FIELD CHANGE DIRECTIVE

No. 06

PROJECT: **Truman Waterfront Park Phase 1A**

Description: **Remove approximately 141 lineal feet of buried former seawall**

Truman Waterfront Park Project GR0703 Field
Coordination SK-002

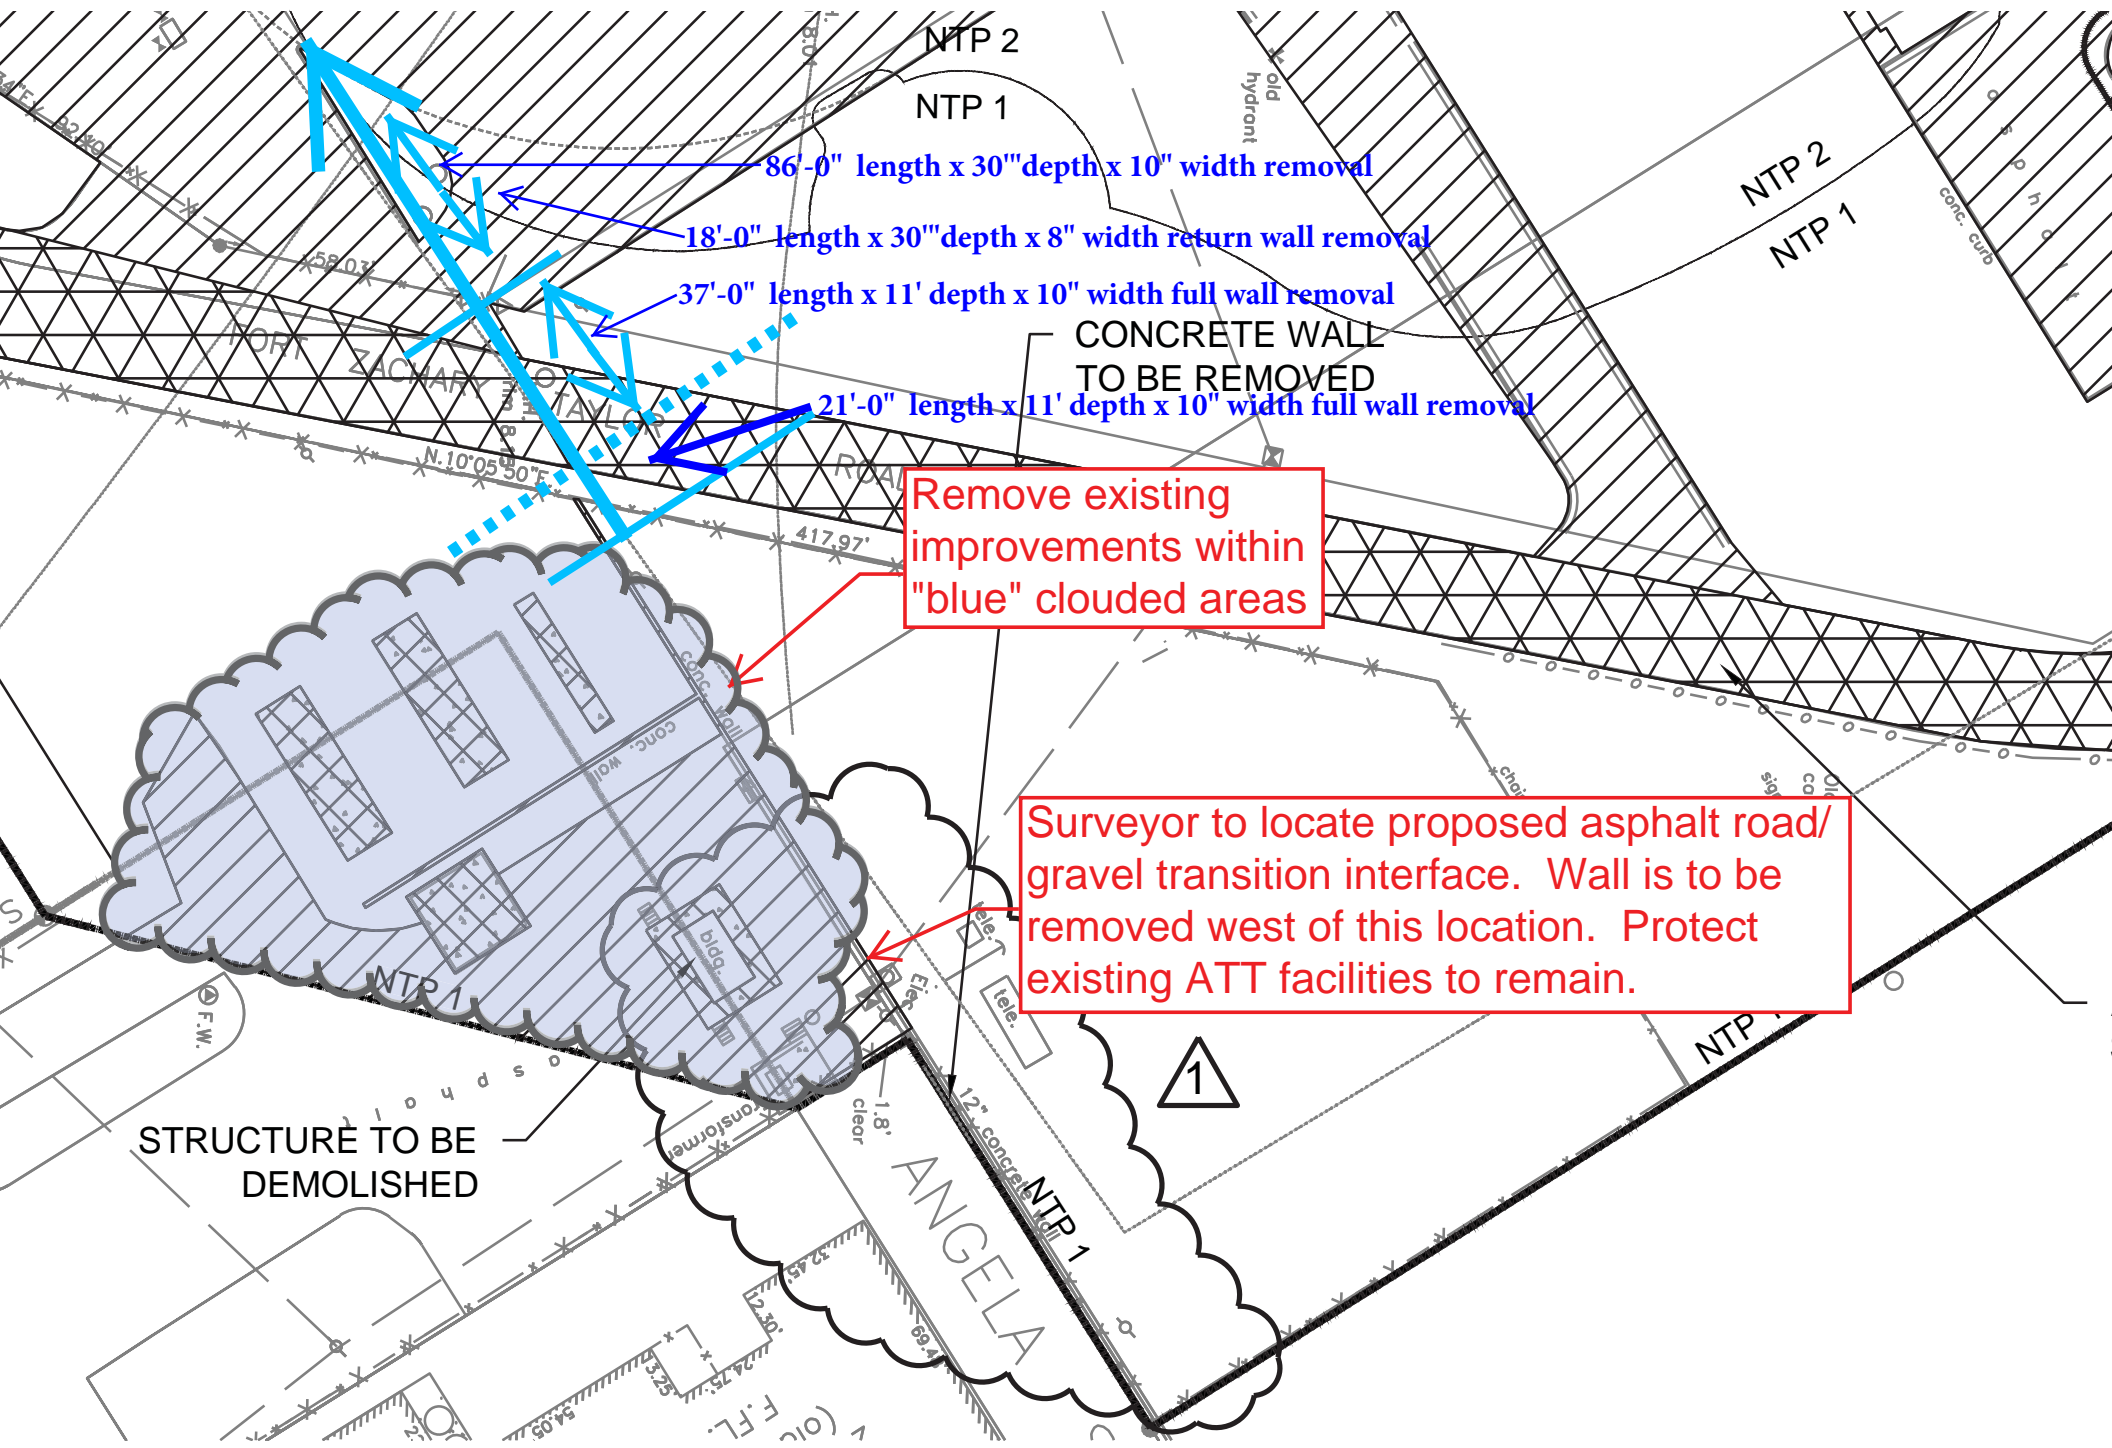
Demo of the concrete retaining wall from 14'-0" from property line per RFI 023 revealed the concrete wall was 6'-9" below grade, greater than 4'-5' typical for retaining wall condition. The wall continued beyond location where wall visibly terminated to into the ground: 21' length x 11' depth x 10" [not included in this CO].

The wall continued further under the pavement of Fort Zachary Road and beyond to a depth of 10'-0" to 11'-0" typical.

Additional demo requested for Unforeseen Seawall Condition:

86' length x 2'-6" depth x 10" partial wall removal only

18' length x 2' -6" depth x 8" partial wall removal only

37' length x 10' depth x 10" width full wall removal

as required for structures placement.
